Sneha Kinetic Power Projects Private Limited

Sub: Dikchu HEP (96 MW) in Sikkim by M/s. Sneha Kinetic Power Projects Private Limited - Request for approval of scope change for already obtained Environmental clearance vide your letter No: J-12011/91/2007-IA.I dated 01-04-2008 – reg.

Detailed Report on changes post Environmental Clearance

96MW Dikchu Hydro Electric Project

SALIENT FEATURES

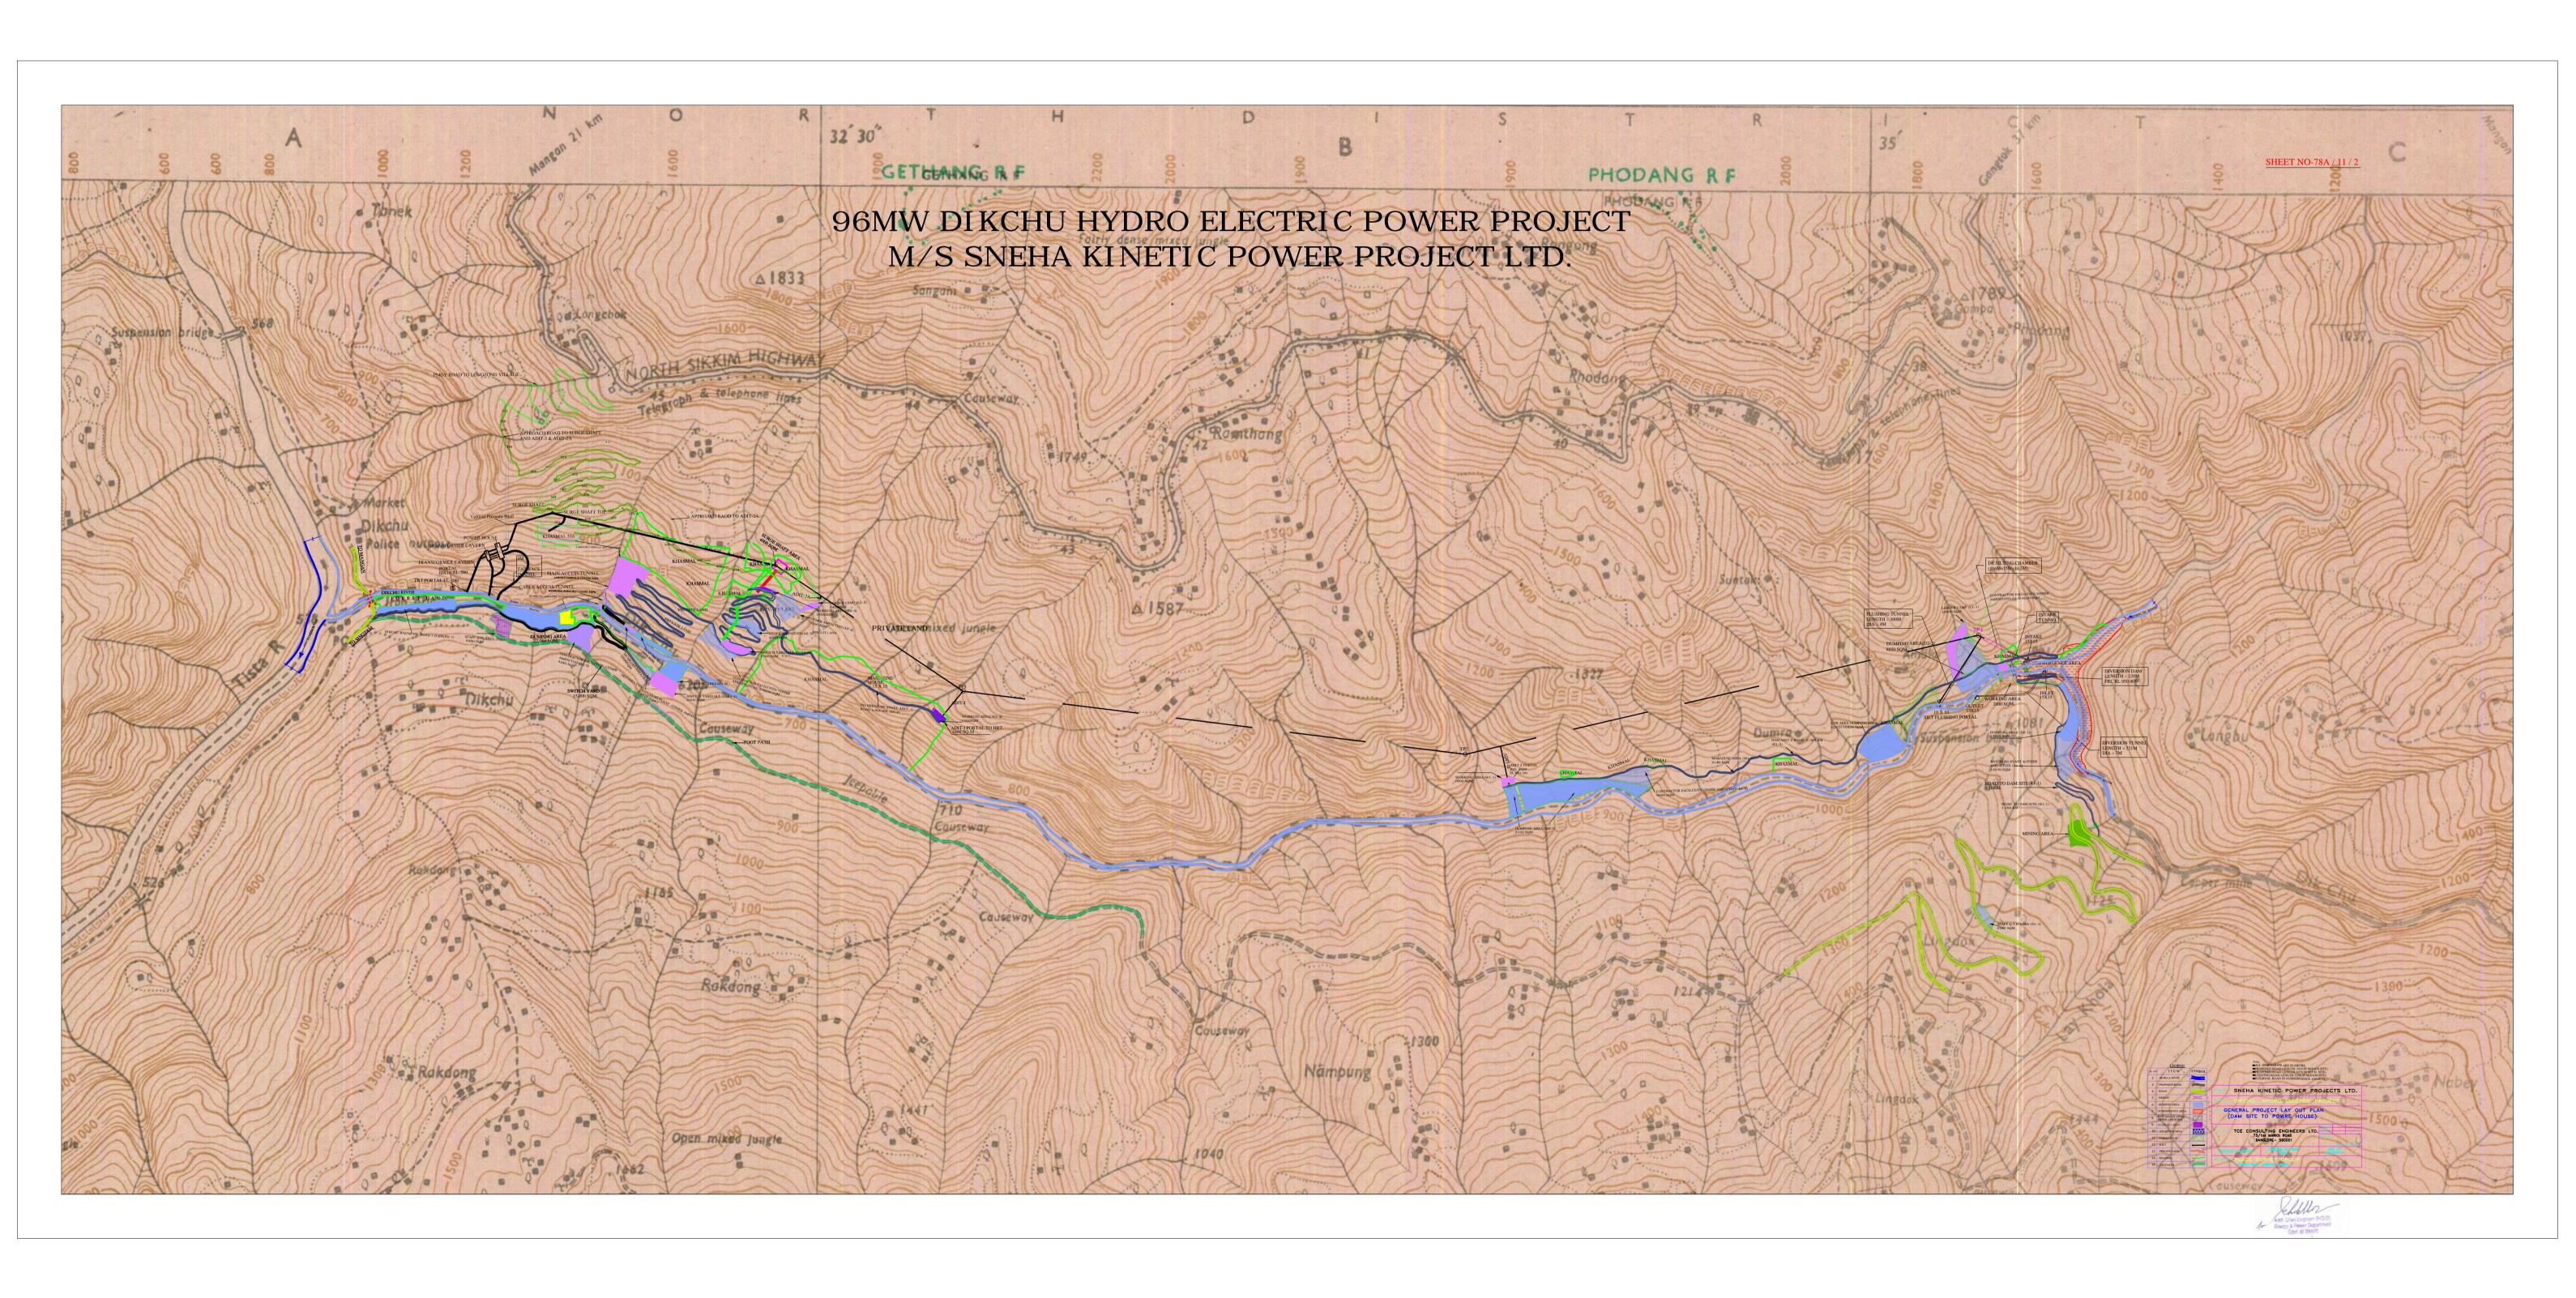
This has reference to your letter dated 15-10-2011 where in revised salient features were enclosed for perusal.

In this context it is mentioned that the revised Salient features and layout have been examined and proposed changes have been found acceptable, duly signed Salient features and Layout are enclosed herewith for your reference and record."
